Access Compliance Report

Public Rights-of-Way

(Curb Ramps)

Intersection ID: 13118	Main Street: E_7TH_ST	Cross Street: CENTRAL_AV	Location: S
ADA ID: 8F02277FD704	Ramp Type: Para	Initial Pass/Fail: Fail	Overall Compliance: No
Severity Score: 26.25			
Codes/Mitigation Info/Possible Solution		Field Measurements/Component Compliance

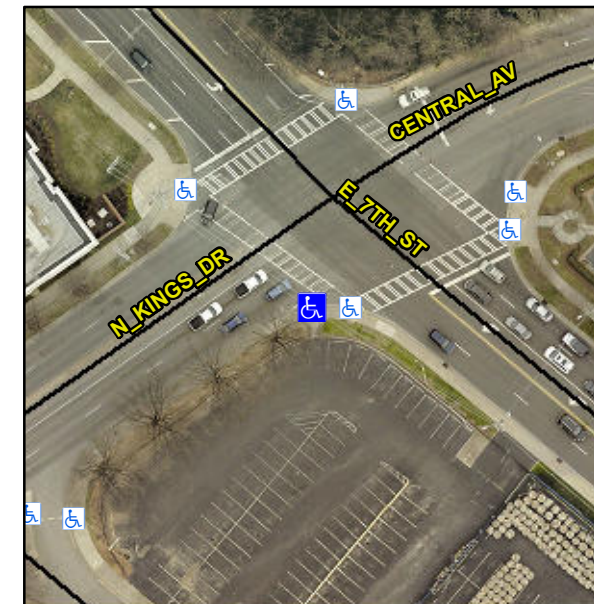
RT RP < 5%

R304.3.2, R304.5.3

Compliance	Description	Data	Compliance	Description	Data
N/A	Ramp Length LT (in)	66.5	N/A	Ramp Length RT (in)	66.0
Yes	Ramp Width LT (in)	60.0	Yes	Ramp Width RT (in)	60.0
No	Ramp Slope LT (%)	12.5	Yes	Ramp Slope RT (%)	0.0
No	Ramp XSlope LT (%)	4.1	No	Ramp XSlope RT (%)	2.9
N/A	Landing Length (in)	N/A	N/A	DWS Provided?	N/A
N/A	Landing Width (in)	N/A	N/A	DWS Contrast?	N/A
N/A	Landing Slope (%)	N/A	N/A	DWS Length (in)	N/A
N/A	Landing X Slope (%)	N/A	N/A	DWS Full Width?	N/A
N/A	Landing Curb? (Y/N)	N/A	N/A	DWS Offset (in)	N/A
N/A	Shared Landing?	N/A			
N/A	Gutter Ponding?	N/A	N/A	Gutter Slope (%)	N/A
N/A	Gutter Lip Ht (in)	N/A	N/A	Gutter X Slope (%)	N/A
N/A	Painted X Walk1?	Yes	N/A	Painted X Walk2?	N/A
	X Walk 1 Direction	To NW		X Walk 2 Direction	N/A
N/A	X Walk 1 Width (in)	110.0	N/A	X Walk 2 Width (in)	N/A
	X Walk 1 Slope (%)	2.0		X Walk 2 Slope (%)	N/A
	X Walk 1 X Slope (%)	5.3		X Walk 2 X Slope (%)	N/A
N/A	Ramp inside XWalk1?	Yes	N/A	Ramp inside XWalk2?	N/A

Remove & Replace Entire Ramp.
